6 AN ORDINANCE approving Change Orders No.  
7 15 and 16 in connection with Water  
8 Pollution Control Plant Additions.

PROJECT Water Quality Control Project OWNER City of Fort Wayne, Indiana

CHANGE ORDER NO.

PROJECT Water Quality Control Project OWNER City of Fort Wayne, IndianaDIVISION/~~XXXXXXXX~~ I - Water Pollution Control Plant AdditionsCHANGE ORDER NO. 16TO: Hagerman-Shambaugh - Joint Bidders% Hagerman Construction CorporationP.O. Box 690 - 403 Strauss BuildingFort Wayne, Indiana 46801

Item No. *1**12-22-76**2-2*For *FT WAYNE W.P.C.P. - PROPOSED NEW SUMP PUMP IN EXIST. PIPE GALLERY*LOCATION PLAN OF PROPOSED NEW SUMP PUMPSECTION A-A

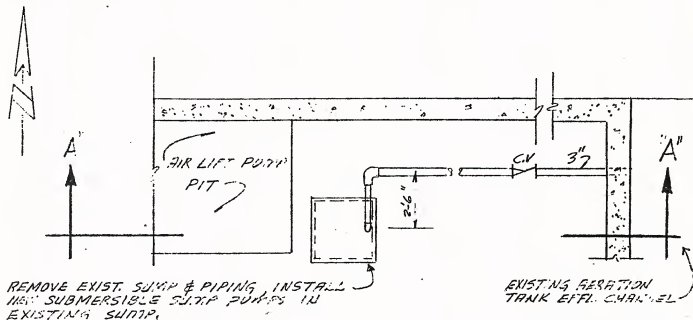
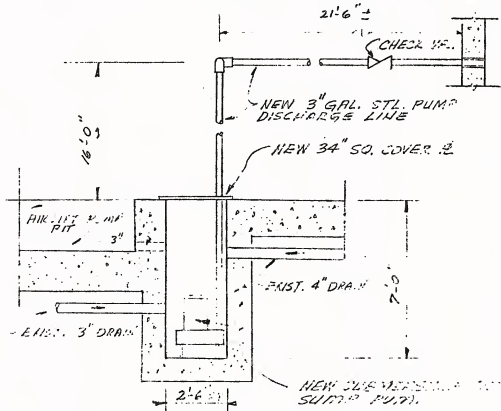
Furnish all labor and material necessary to add two new overflow boxes with sump pumps to the two new sample sinks located in the new and existing aeration pipe tunnels. See attached sketches. Following is a breakdown of the cost:

1. Necessity for change: The addition of an overflow sump and submersible pump at the two new sample sink locations are necessary to prevent the sinks from overflowing while the secondary settling tanks are being drained for servicing. Normal operation will be that the new sinks will drain to the existing drain system, but when the plant drain system is flowing full, it will not allow the sink to drain by gravity. The proposed change will permit continuous sampling of secondary effluent.
- \_\_\_\_\_
- \_\_\_\_\_
- \_\_\_\_\_

SPECIFICATIONS FOR NEW DUPLEX SUMP PUMP

Furnish and install one duplex submersible pump system to be located in the existing aeration tank pipe gallery as shown on the drawings. The system shall include pumps, electrical controls, level controls, and accessories to make a complete automatic system.

Each pump to have a capacity of 110 G.P.M., at a total head of 25 feet. Motor to be 1 horsepower, 4 phase, 60 Hertz for operation at 480 volts.

ITEM NO. 2

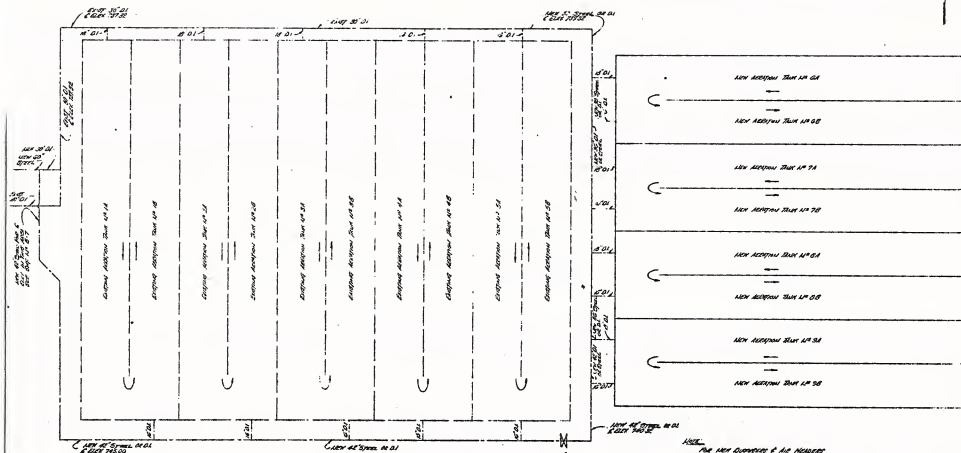
Furnish all labor and material necessary to install a new space unit heater in the new gas compressor room located in the digester building. Following is a breakdown of the cost:

1. Necessity for change: The addition of a new space heater located in the digester gas compressor room is necessary to provide heat for the compressor room during periods when the gas compressors are out of service. Normal operation of the compressors will provide more than enough heat to keep the gas aftercooler water supply and drain lines from freezing.
- \_\_\_\_\_
- \_\_\_\_\_
- \_\_\_\_\_
- \_\_\_\_\_

SPECIFICATIONS FOR NEW SPACE HEATER FOR COMPRESSOR ROOM

Furnish and install one new space unit heater in the southwest corner of the new gas compressor room of the Digester Control Building.

The unit shall be a vertical hot water type unit mounted at the ceiling of the compressor room. The unit shall operate with a hot water supply at a temperature of 200 degrees F. and shall have a capacity of 39.5 MBH with a 885 CFM fan, driven by a 1750 RPM, 1/6 HP, 115 Volt single phase electric motor. The unit shall be controlled from a wall mounted thermostat located in the compressor room.

The electrical power supply shall be furnished through a circuit breaker and conduit from panel MCC-P3A.

The unit heater, thermostat, power wiring and control wire shall be totally explosion proof.

HNTB  
JOS-FORT WAYNE W.V.A.  
NO. 3263  
REV. DATE: 12-23-76  
PIPE CHASE VENTILATION

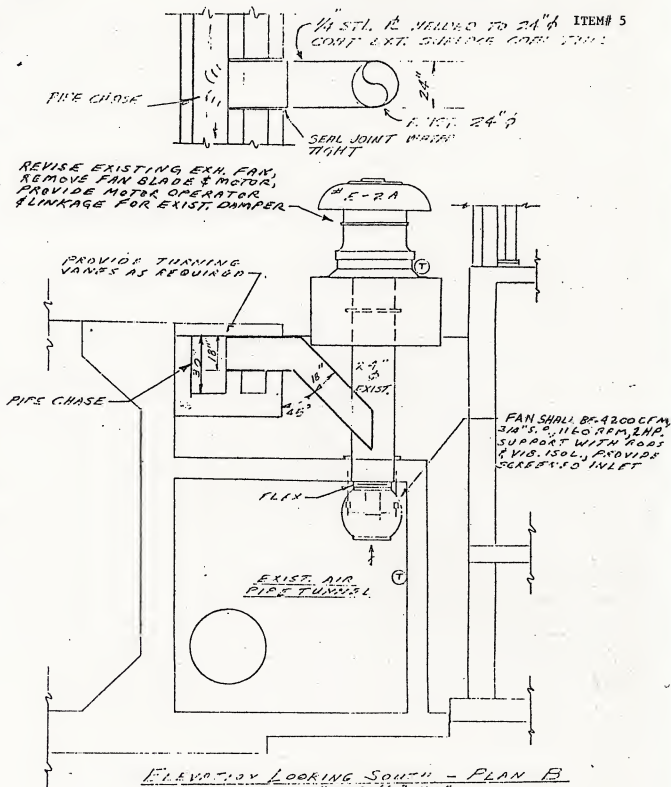
Furnish all labor and material necessary to add a new 18-inch square steel air duct and fan to the new chemical pipe channel as shown on attached sketch. This addition also involves revising one of the new exhaust fans and adding new thermostats. Following is a breakdown of cost:

1. Necessity for change: The request for the addition of a heating system for the new concrete pipe channel extending from the existing Chlorination Building to the new railroad tank car unloading facility is necessary to prevent a water line to a safety shower located at the facility and the chemical line from freezing during the cold months of the year.
- \_\_\_\_\_
- \_\_\_\_\_
- \_\_\_\_\_
- \_\_\_\_\_

1. BALANCE AIR @ 2400 CFM TO THE SOUTH & 1600 CFM TO NORTH
2. MOTOR OPERATED DAMPER IN REVISED E-2A WILL BE ACTIVATED BY THERMOSTAT ON EXTERIOR SURFACE OF HOOD IF TEMP. DROPS BELOW 40°F.
3. THE EXHAUST FAN WILL BE ACTIVATED BY A THERMOSTAT IN TUNNEL IF TEMP. RISES TO 65°F.

Job No.  
**3263-43-00**Sheet No.  
**1 of 1****FORT WAYNE, W.P.C.P. -- AERATION BLDG. -- FLOOR REIN. DETAIL****SECTION "A-A"****CONNECTION DETAIL****SECTION "B - B"**

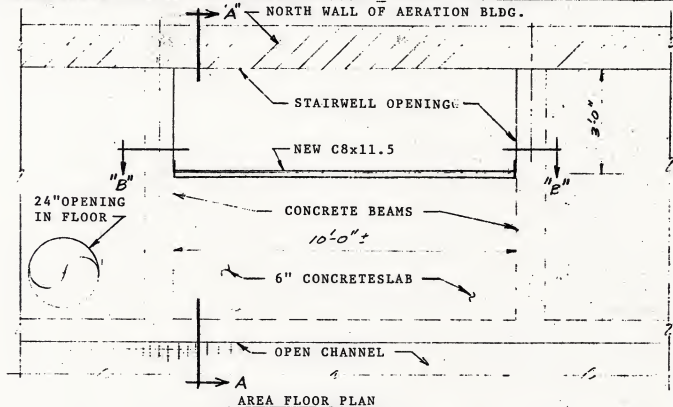
Furnish all labor and material necessary to install one new structural steel channel to reinforce the existing concrete slab, located at the stair opening in the existing Aeration Building. See the attached sketch for structural details.

1. Necessity for change: The installation of a new C 8x11.5 structural member located at the stairwell opening in the existing Aeration Building is necessary because the new Motor Control Center No. P-4 will be located over the counterlevered portion of the existing floor slab and the Motor Control Center load is greater than anticipated.
- \_\_\_\_\_
- \_\_\_\_\_
- \_\_\_\_\_
- \_\_\_\_\_
- \_\_\_\_\_
